CONSTRUCTION CHANGE ORDER

PROJECT: Sessom Creek Bank Stabilization and WW Replacement - Phase 2
CONTRACT NO.: 224-002

Date Prepared: 9/5/2025
Change Order #: 4

Re: Sessom Creek Bank Stabilization & Wastewater Replacement – CO #4

**SANITARY SEWER PLAN &
PROFILE LINE A STA. 8+00
TO END**

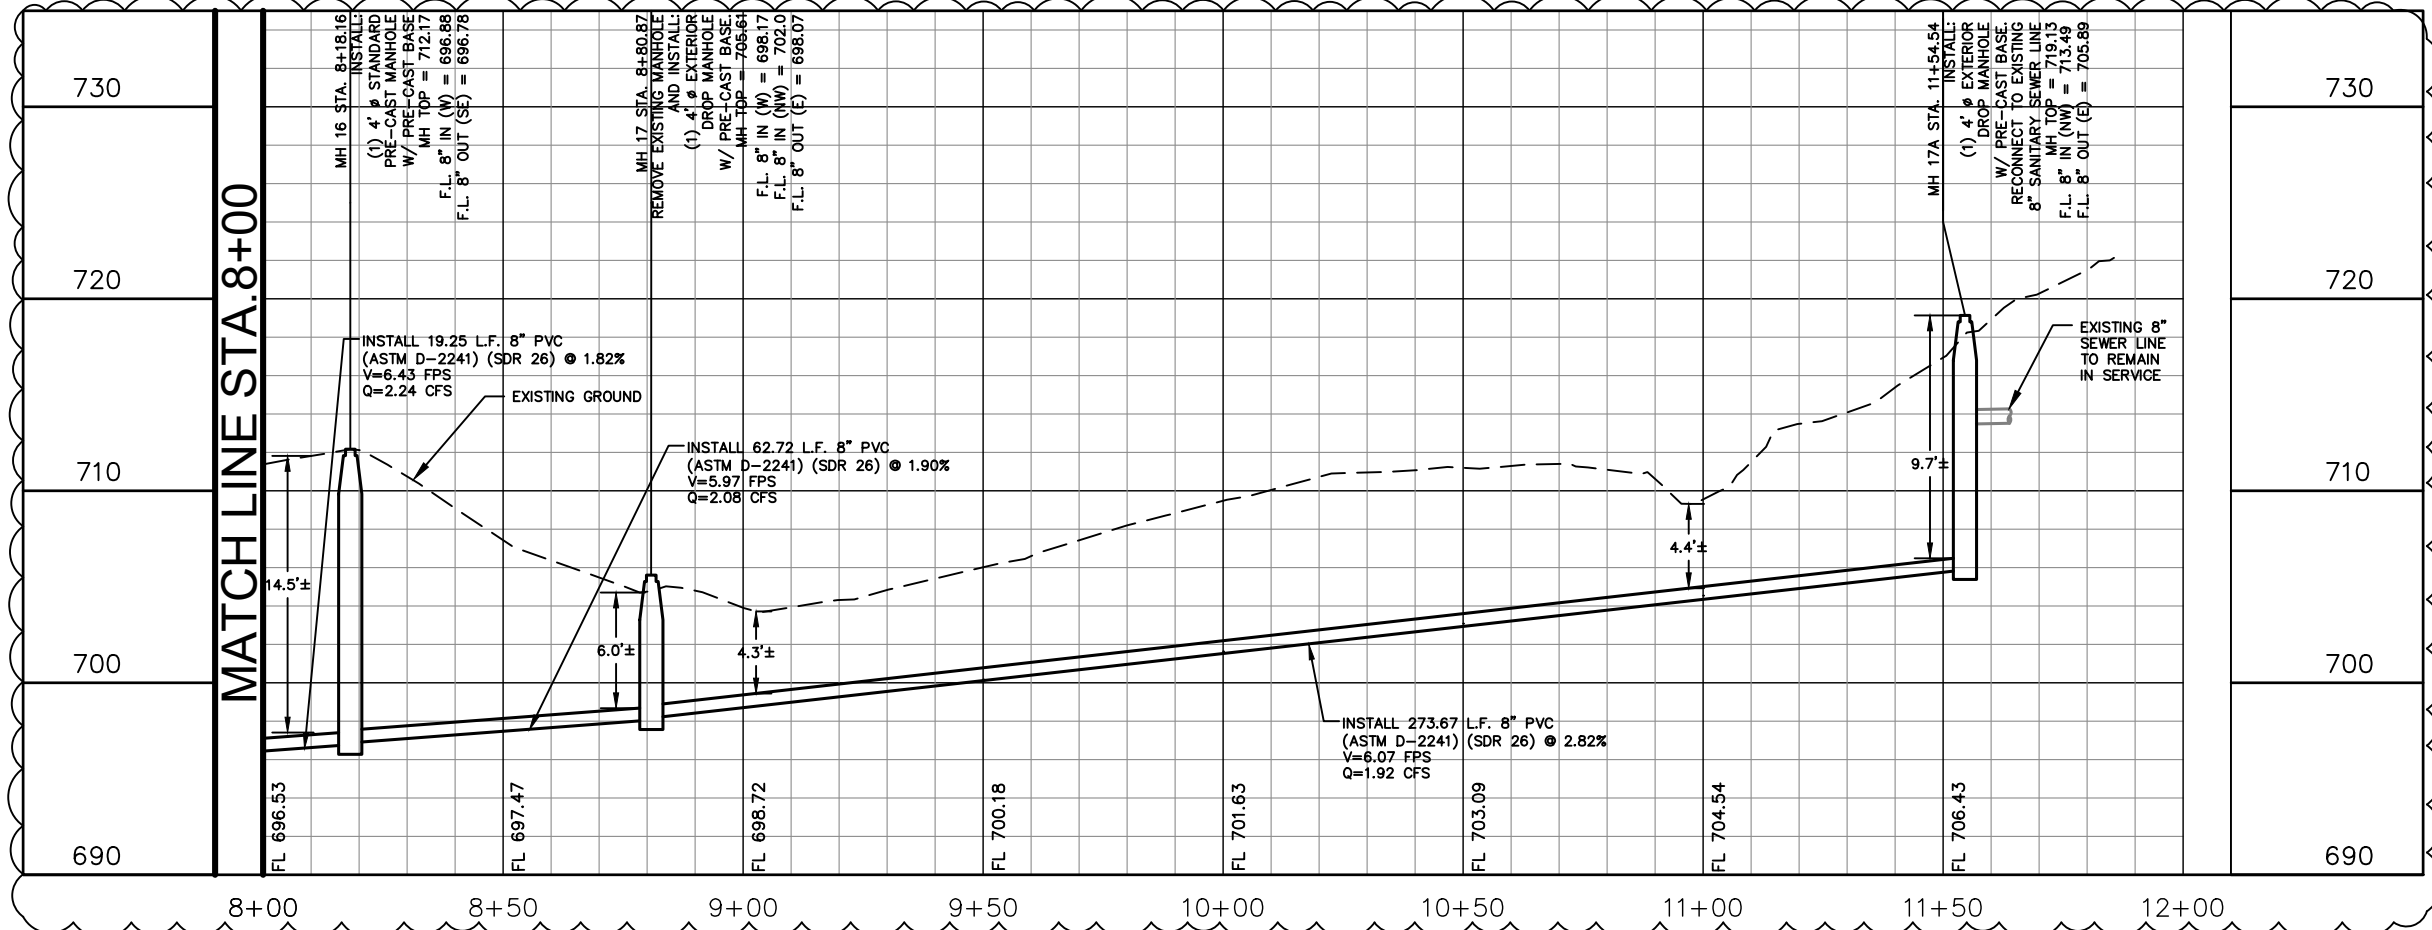
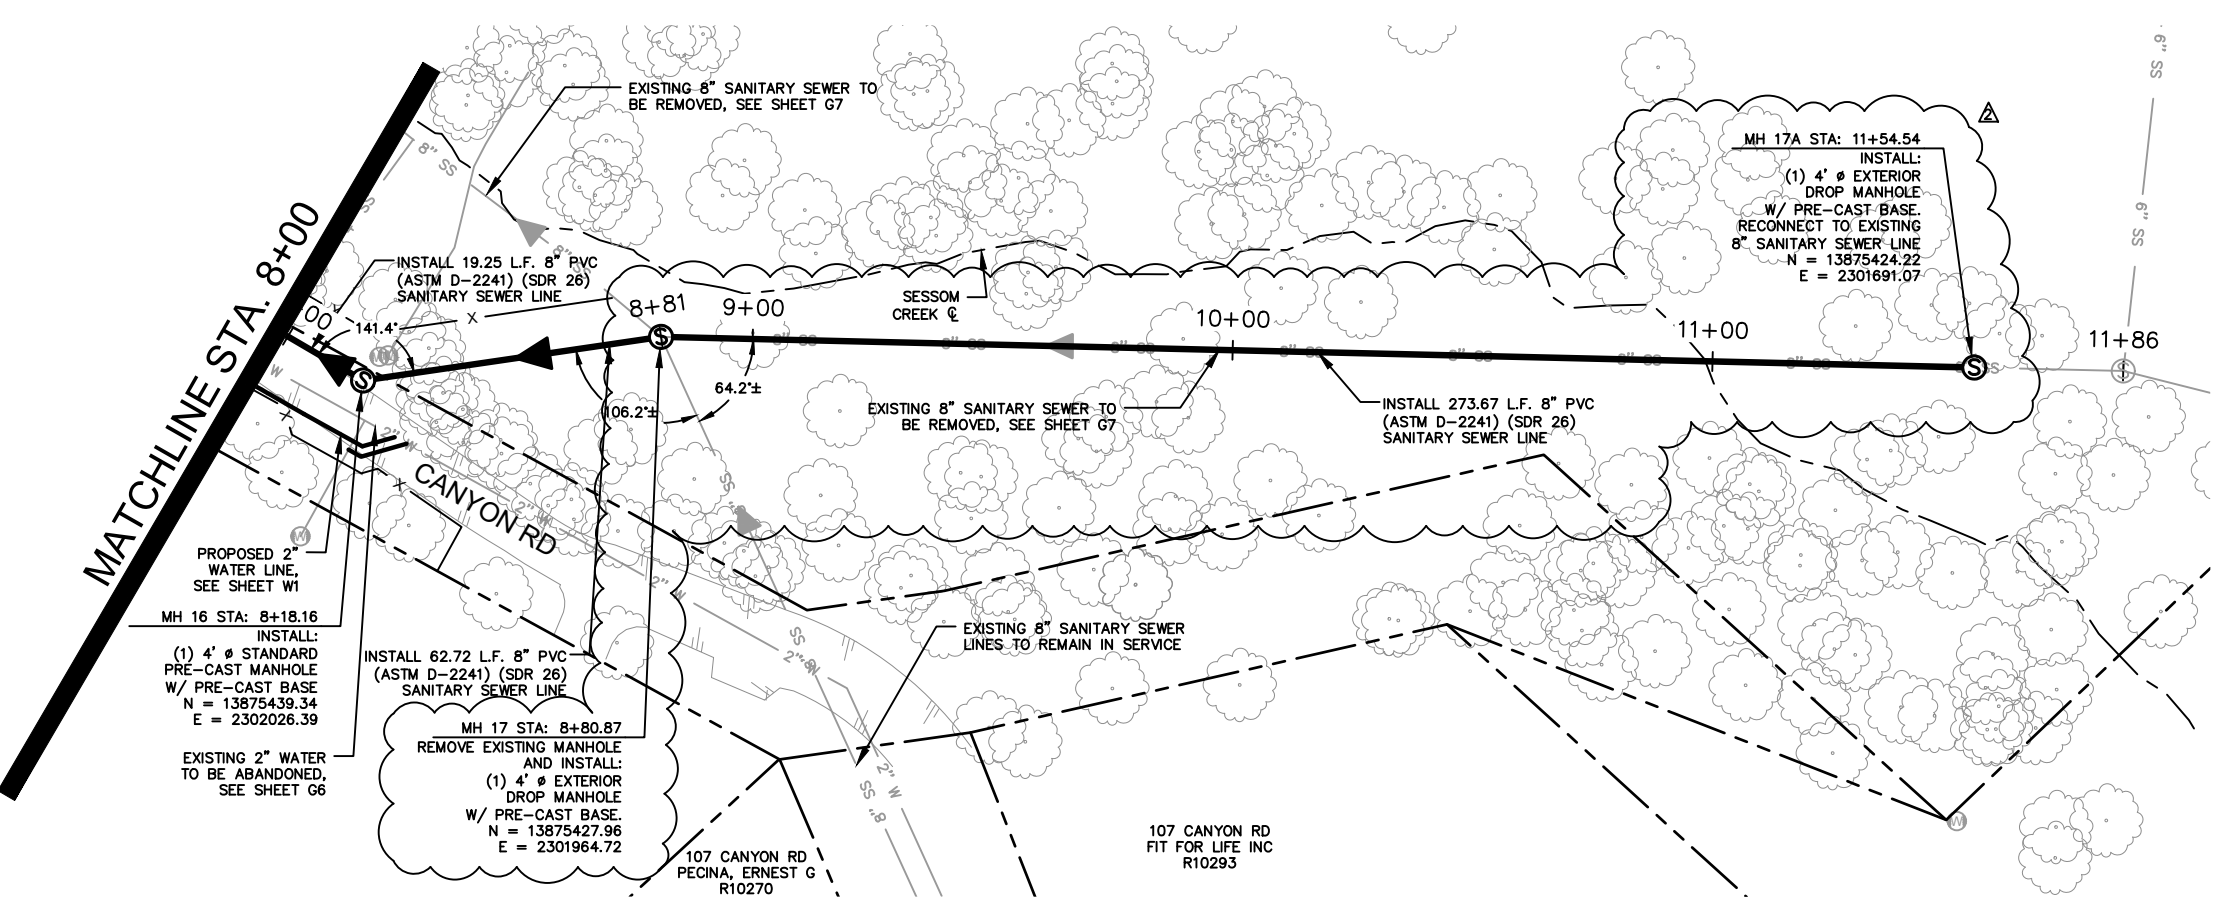
Corresponding quantity adjustments per RFI 14a:
Additional WW Replacement = Remove exposed wastewater line upstream of MH 17 and replace with new WW line & appurtenances
Additional Roadway Repair = Full road repair up to the concrete driveway of 107 Canyon Rd to better coincide with limits of W/WW replacement
Revised water services = 1" blue poly (in lieu of 2" PVC) per COSM Public Works preference
Revised tree protection (additional tree removal & corresponding mitigation measures), erosion control, and quantity sheets to correspond with the plan revisions noted above
Add 40 Working Days (approx. 2 months) to the Project Schedule (PS-1):
> The Contractor must achieve Substantial Completion within **250 Working Days** after the Project Start Date = Wednesday, May 6, 2026
> The Contractor must achieve Final Completion within **295 Working Days** after the Project Start Date = Monday, July 13, 2026

2-INCH WATER LINE
RE-ROUTE PLAN

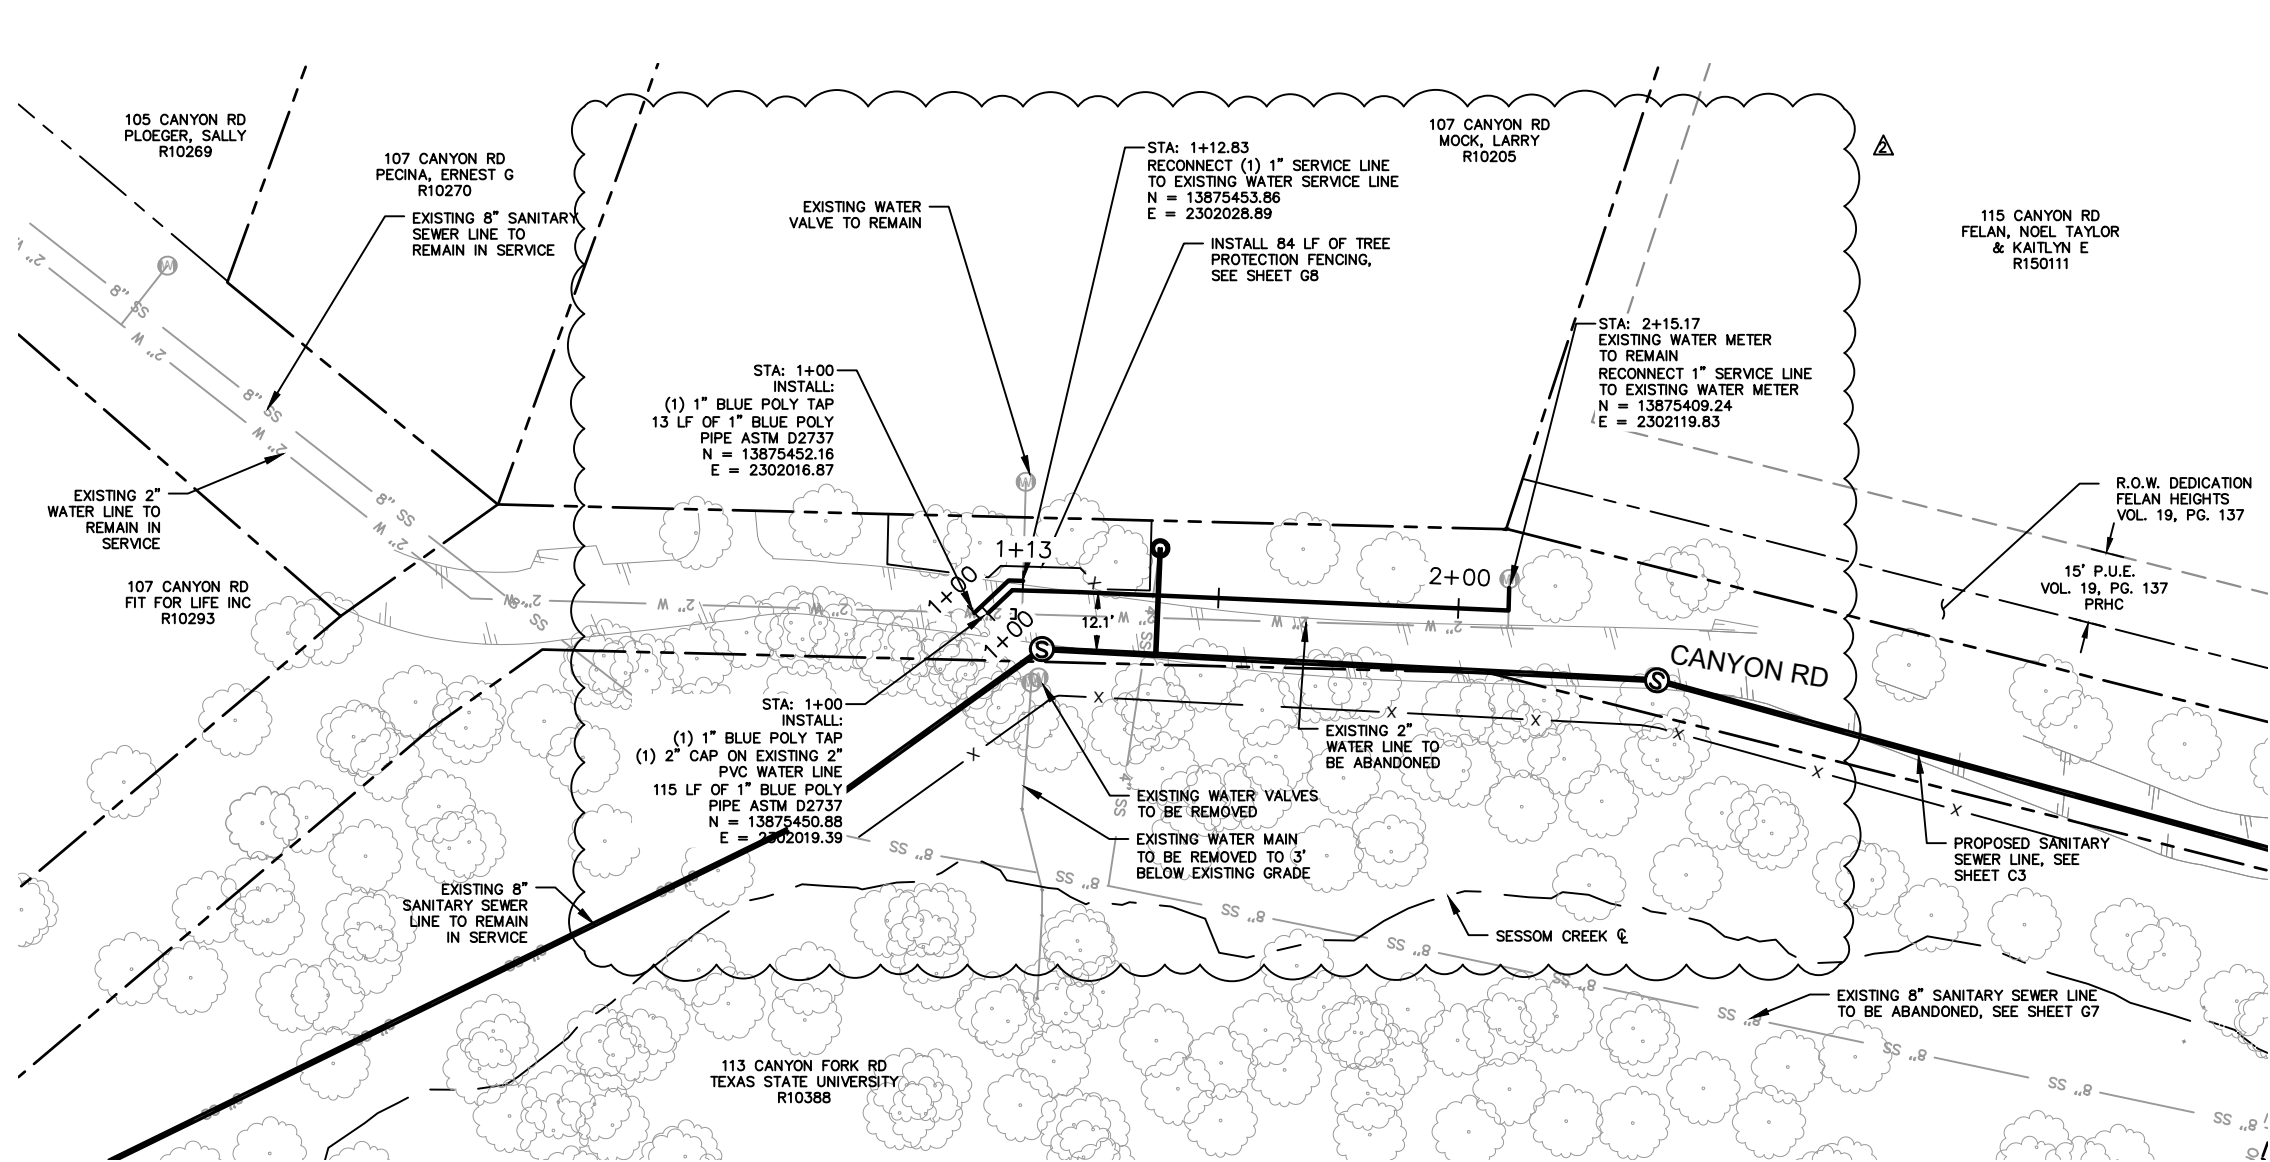
0.00	0.00					0.00	0.00
Backfill Materials (#2 Base) Sheet W1	TON	5.00	24.00	1.000	24.00	13.20		15.77			52.97	264.85
					0.00	0.00					0.00	0.00
Asphalt Road Patch	LS	1.00	24.00	20.000	480.00	264.00	100.00	350.00			1,194.00	1,194.00
Wet Connection	EA	2.00	24.00	30.000	720.00	396.00	50.00		200.00		1,366.00	2,732.00
Pressure Tap	EA	1.00	24.00	60.000	1,440.00	792.00	100.00	700.00	1,500.00		4,532.00	4,532.00
Remove Existing Water Line	LS	1.00	24.00	20.000	480.00	264.00					744.00	744.00
ENGINEER'S BID TOTAL				294.800	7,075.20	3,891.36	723.00	2,955.08	3,290.00	0.00		17,934.64
											Subcontractor cost	3,290.00

2-INCH WATER
SERVICE LINE PLAN

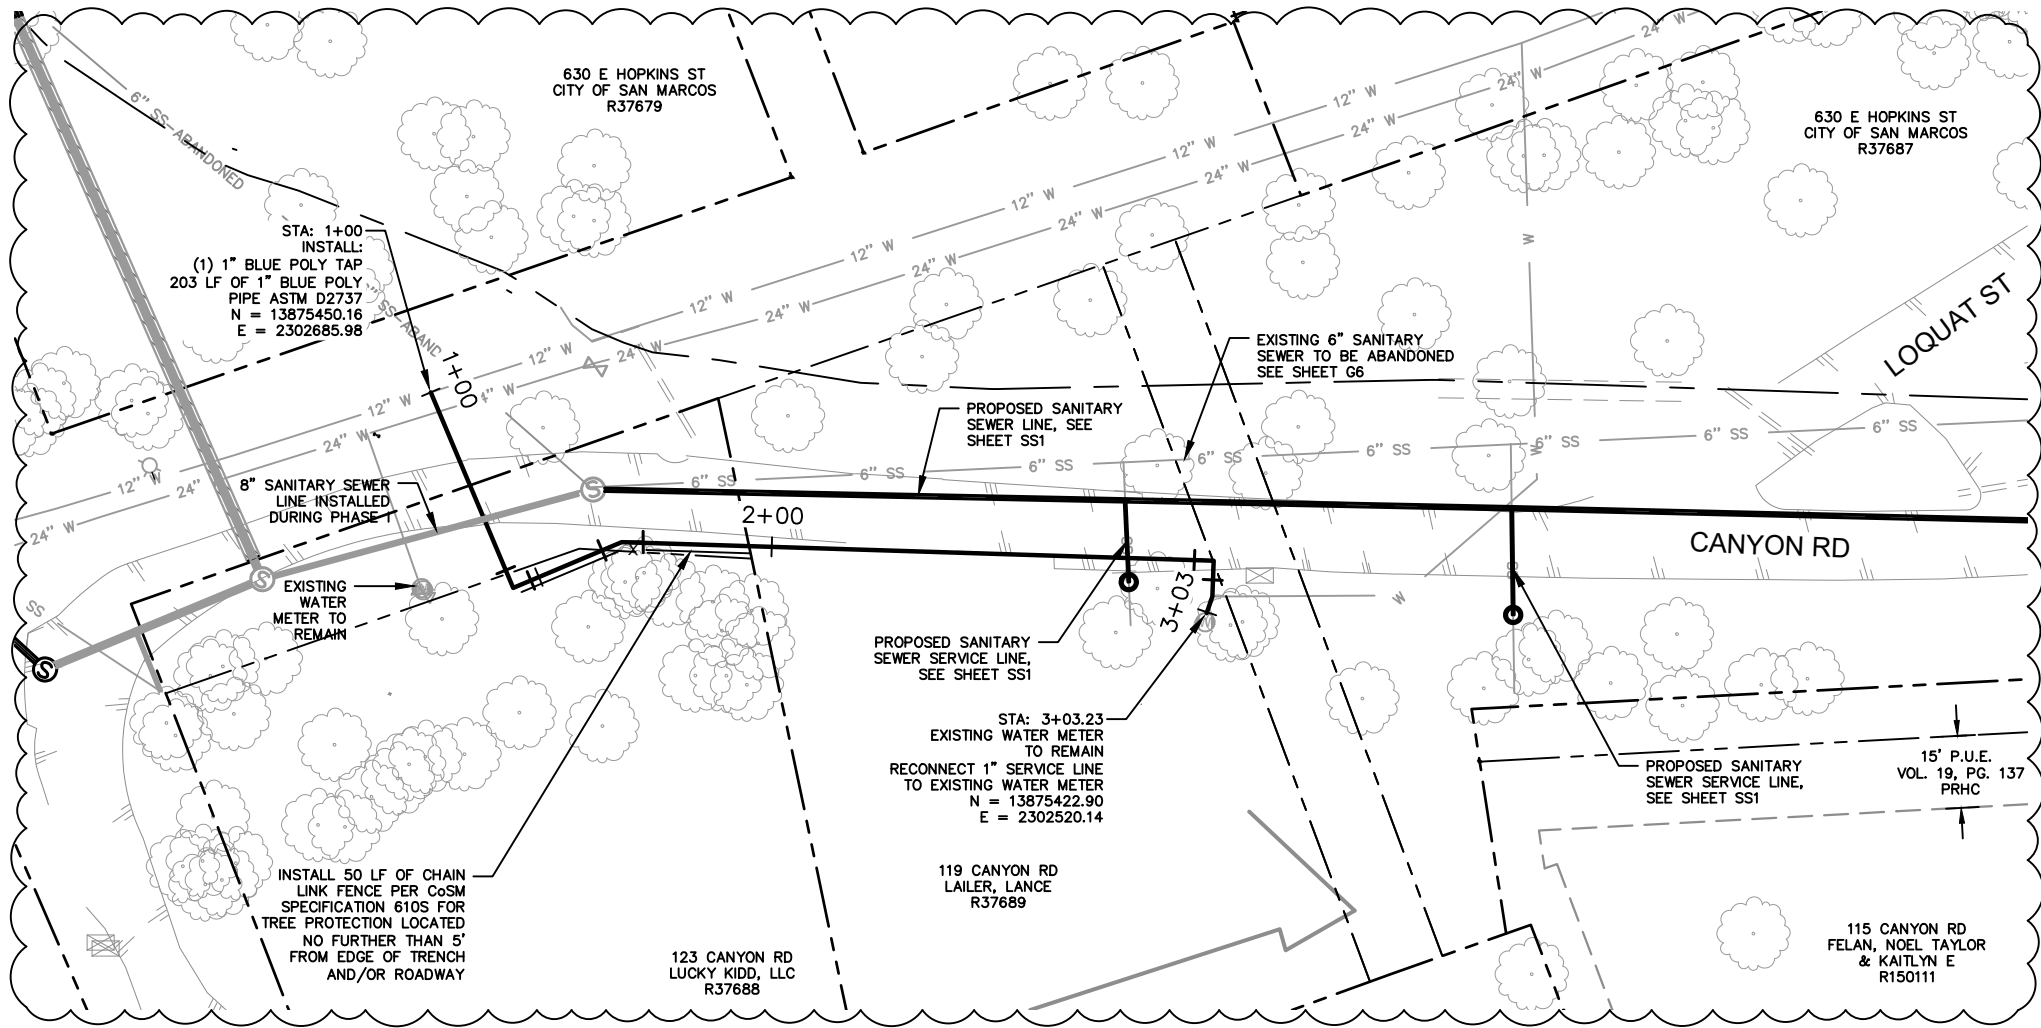
0.00	0.00					0.00	0.00
Sawcut Road	LF	140.00			0.00	0.00			3.00		3.00	420.00
					0.00	0.00					0.00	0.00
Backfill Materials (Flowable Fill) Sheet W2	CY	5.00	24.00	2.000	48.00	26.40			124.00		198.40	992.00
Flowable Fill Delivery	LS	1.00			0.00	0.00			350.00		350.00	350.00
